PROCEDURE FOR IMPLEMENTATION  
OF THE  
INTERMITTENT STREAM POLICY  
HUGHES CREEK AND LICK FORK CREEK  
MOUNTAIN VIEW, ARKANSAS

January, 1984

McCLELLAND CONSULTING ENGINEERS, INC.  
900 West Markham  
Little Rock, Arkansas 72201

SIMULATED D.O. PROFILES FOR ALTERNATIVE TREATMENT LEVELS

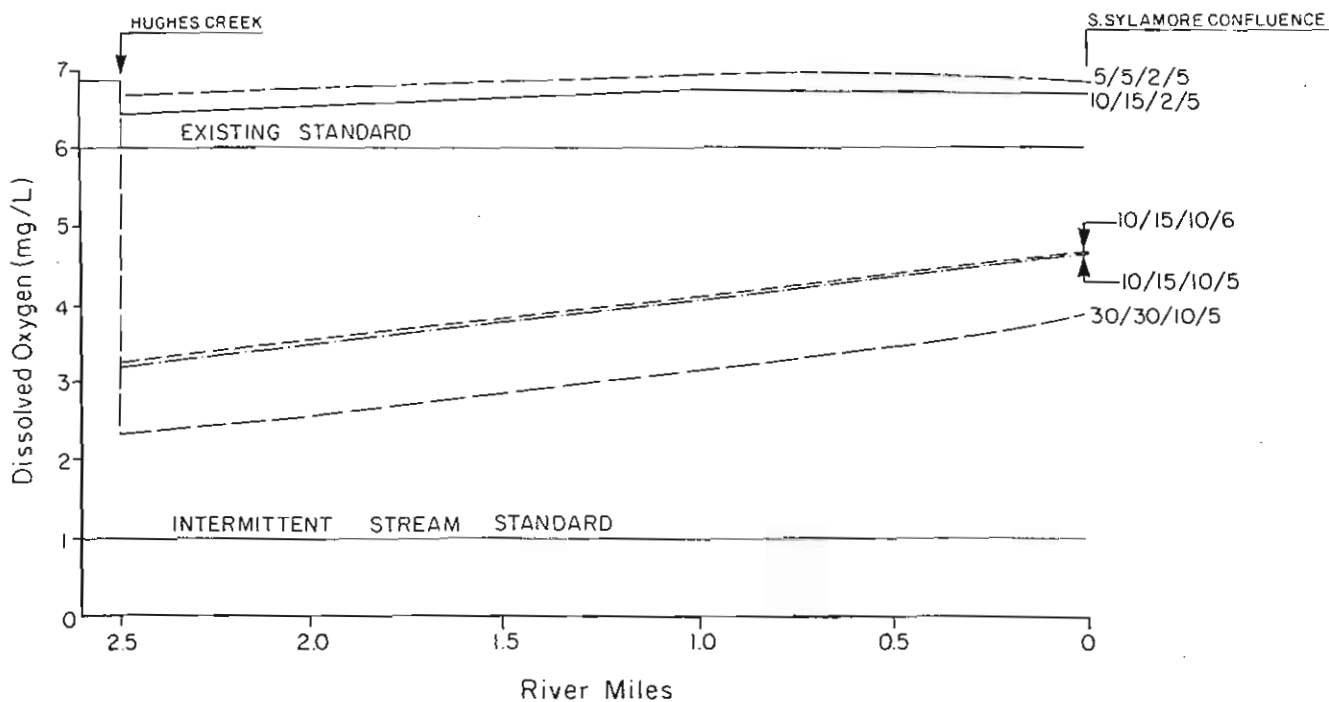
The critical summer temperature used (23.5<sup>0</sup> C.) in the modeling effort is too low. This would tend to bias predicted D.O. values in an upward fashion. During late summer, it is not uncommon for small, shallow streams to closely reflect air temperatures and reach 28-30<sup>0</sup> C. It is important that our agency know what effect these higher critical temperatures would have on predicted D.O. values, especially, in South Sylamore Creek.

There is also some concern over the method in which the predicted D.O. value for South Sylamore Creek was obtained. It is our feeling that the 8.3 D.O. value (80% saturation) assumed for a summer D.O. value in South Sylamore Creek is too high, and that in reality D.O. violations might possibly occur under the proposed treatment plan. Also, it is our opinion that the model did not satisfactorily address predicted D.O. values of South Sylamore Creek.

the study data indicates that advanced treatment (10/15/2/5) would allow the D.O. in Hughes Creek to recover before its confluence with Lick Creek. Should this be the case, we would not object to the reclassification of Hughes Creek as "intermittent", providing our previous questions are satisfactorily addressed.

We agree that the critical temperature used in the model (23.9°C) is too low for these streams, however, according to the sensitivity analyses done in the report the dissolved oxygen in Lick Fork Creek will remain above 6 mg/l even with a 4 degree increase in temperature during critical conditions with a 10-15-2-5 (CBOD<sub>5</sub>-TSS-NH<sub>3</sub>-D.O.) effluent. Therefore, we are recommending this value as the required effluent limit.

Assuming an increase in flow and velocity during the spawning period, we used a reaeration rate based on stream slope which indicated that the general standard of 6 mg/l D.O. would be met in Hughes and Lick Fork Creeks during this time (when stream temperatures are 20°C or lower). These spawning period runs utilize seasonal limits of 10-15-10-6.

The predicted D.O. values for South Sylamore Creek appear to be in error in the report. An 80% saturation value at 23.9°C gives a D.O. of 6.8 mg/l. In any event, if our recommended limits (10-15-2-5) are used for the project, then the dissolved oxygen levels in South Sylamore Creek will not be reduced below the existing standard of 6 mg/l.

Based on the 10-15-2-5 treatment level, only Hughes Creek will be necessary to be declared intermittent. Both Lick Fork and South Sylamore Creeks will retain the existing standard.
